**CITY OF TEMPE
DEVELOPMENT REVIEW COMMISSION**

Meeting Date: 06/28/2016
Agenda Item: 3

ACTION: Request for a Development Plan Review for a new restaurant building for PANERA BREAD, located at 1707 W. Warner Road. The applicant is Olsson Associates.

SHEET C1

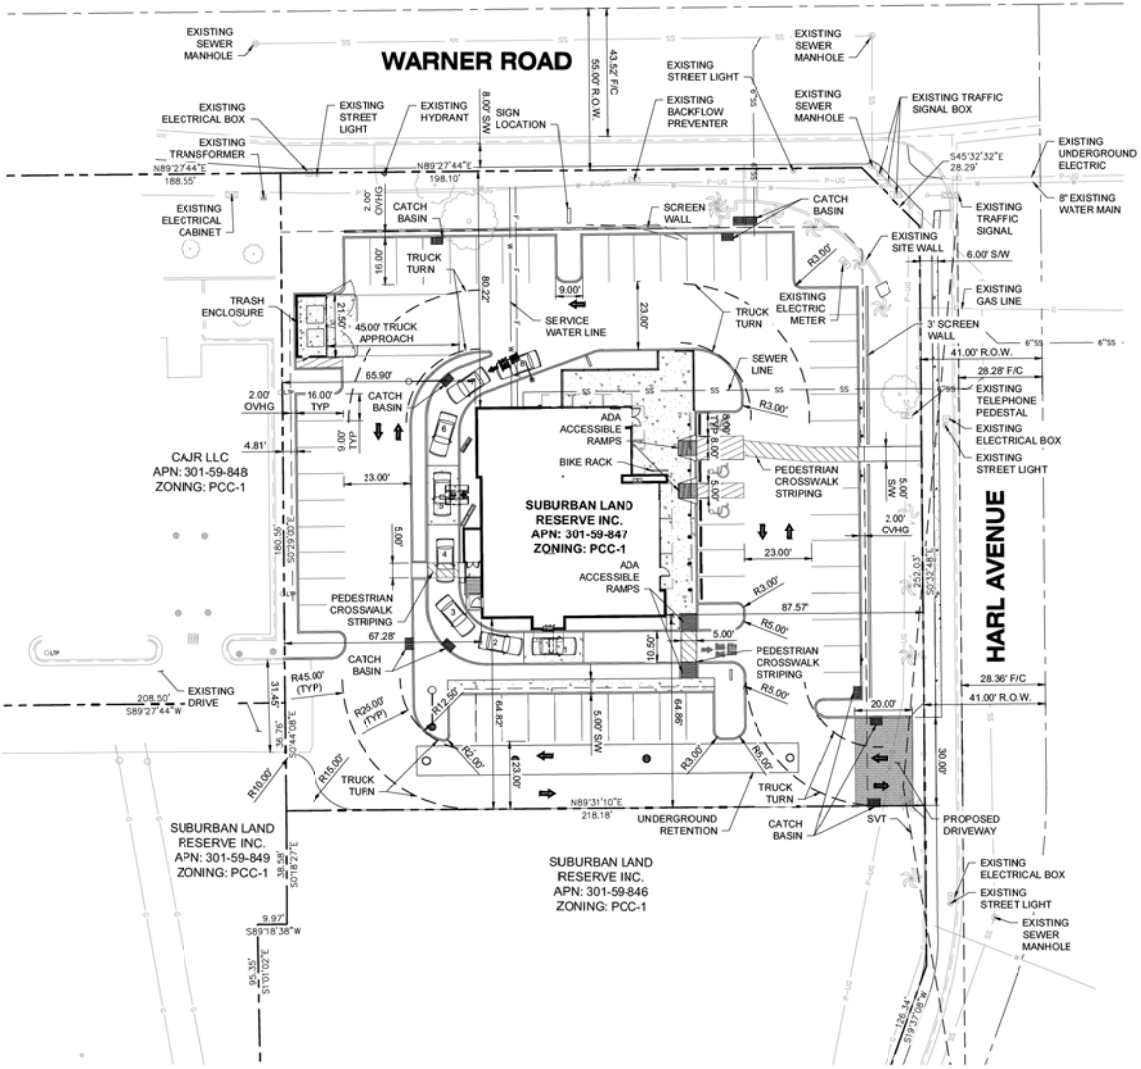
1. The site plan is approved as submitted (May 24, 2016), minor modifications may be reviewed through the plan check process of construction documents; major modifications will require submittal of a Development Plan Review.

2. Provide 8'-0" wide public sidewalk along arterial roadways, or as required by Traffic Engineering Design Criteria and Standard Details.
3. Provide service yard and mechanical (cooling tower/generator) yard walls that are at least 8'-0" tall as measured from adjacent grade and are at least the height of the equipment being enclosed, whichever is greater. Verify height of equipment and mounting base to ensure that wall height is adequate to fully screen the equipment.

5. Provide upgraded integral colored unit paving at each driveway. Extend this paving in the driveway from the right-of-way line to 20'-0" on site and from curb to curb at the drive edges. From sidewalk to right-of-way line, extend concrete paving to match sidewalk.

PRELIMINARY LANDSCAPE PLAN

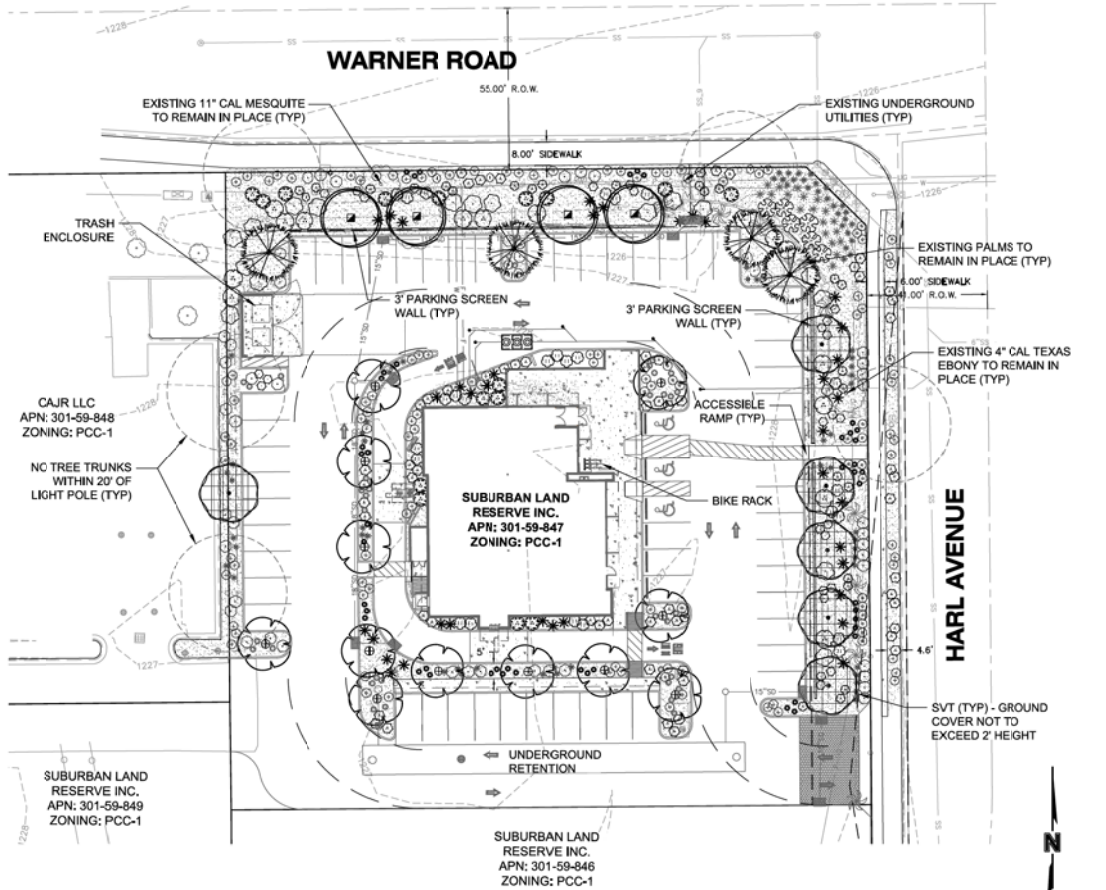
17. The plant palette is approved as proposed and specified on the May 23, 2016 landscape plan. Any additions or modifications may be submitted for review during building plan check process.

EAST ELEVATION

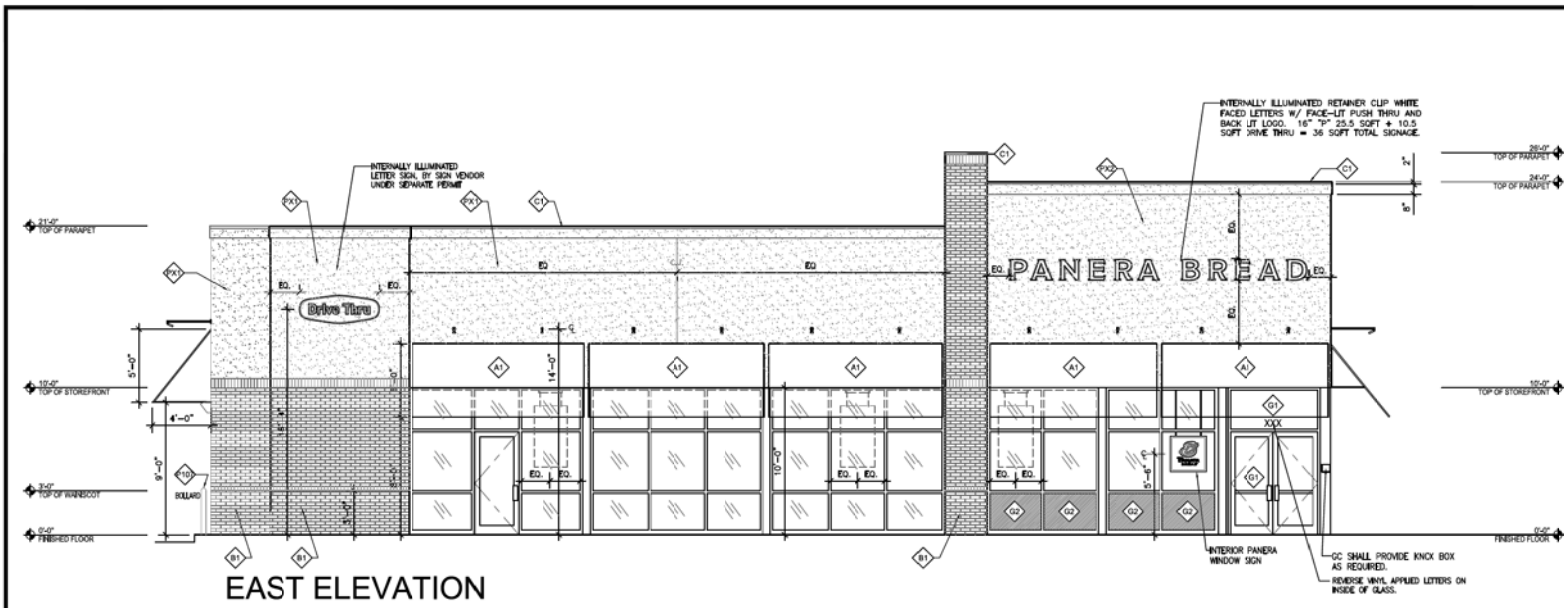
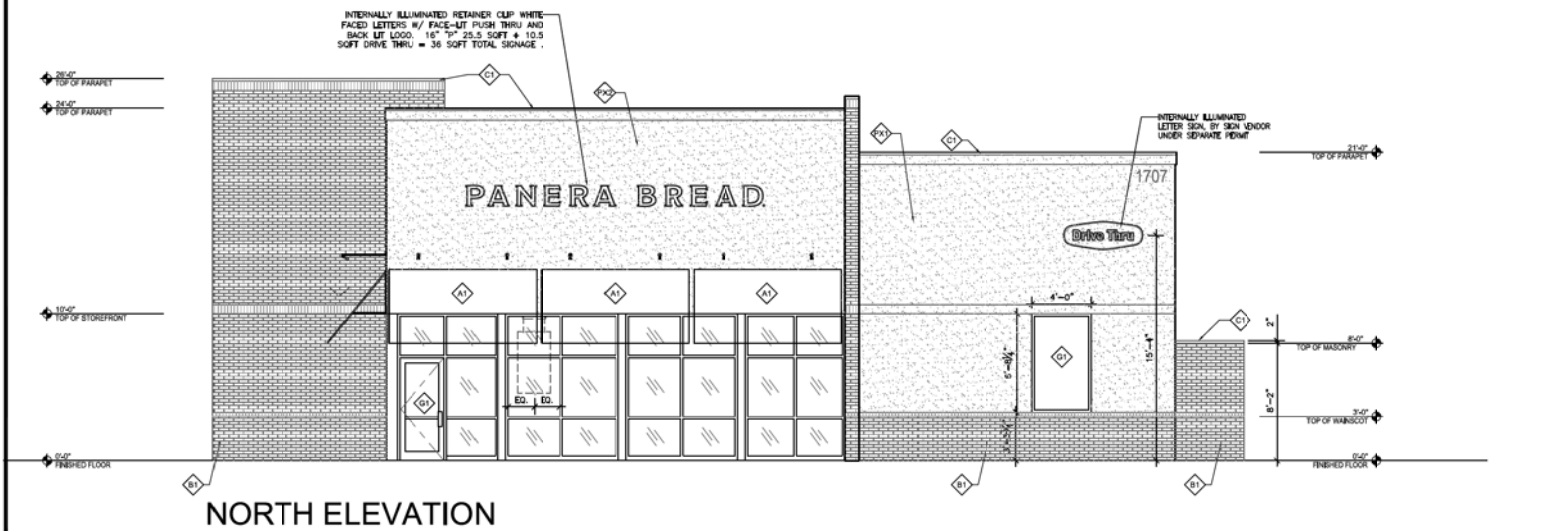
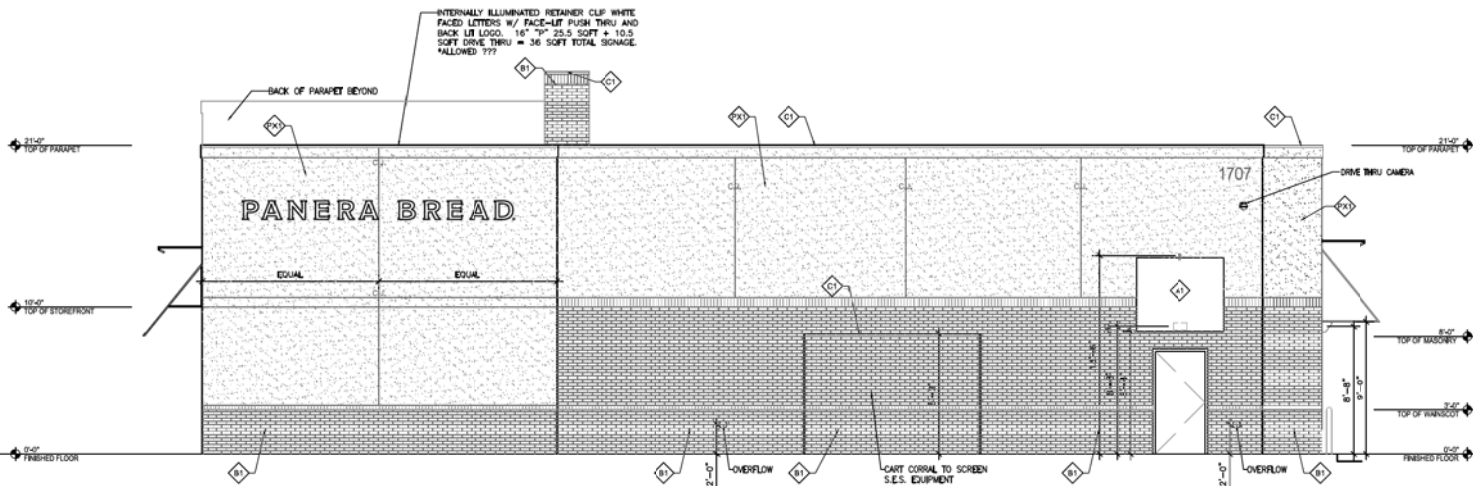
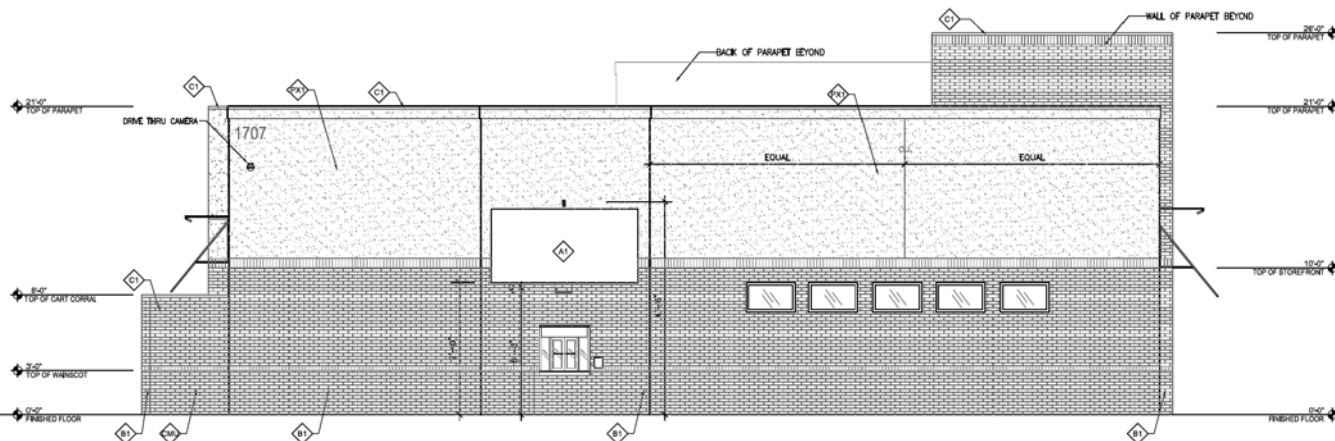
10. The materials and colors are approved as presented (May 23, 2016):
 - Roof – flat with parapet
 - PX1 - Primary Building – EFIS Benjamin Moore HC39 Putnam Ivory (beige)

- PX-2 - Secondary Building – EFIS Benjamin Moore 2111-40 Tauos Taupe (taupe)
 - B1 – Wainscot and column fins - Endicott brick or local – Medium Ironspot #77, thin brick; modular with smooth texture and running bond pattern. Split-faced CMU – Superlite – Apricot #259

- G1 – Storefront - Aluminum storefront Kawneer or equal; dark bronze aluminum w/ 1" insulated clear glazing
 - G2- Spandrel panels at wainscot - Aluminum storefront Kawneer or equal; dark bronze aluminum w/ 1" insulated spandrel

- A1 – Awning – MainStreet+ (or equivalent) fabric awnings Acrylic coated Polyester, flame resistant, 10.2 oz per sq. yd in custom color - Panera, olive. If umbrellas are used on the patio, umbrellas are to match awning fabric color. There shall be no logos or text on awnings or umbrellas.

- C1 – 2" Durolast 2-piece metal coping to match storefront

Provide main colors and materials with a light reflectance value of 75 percent or less. Specific colors and materials exhibited on the materials sample board are approved by planning staff. Additions or modifications may be submitted for review during building plan check process.
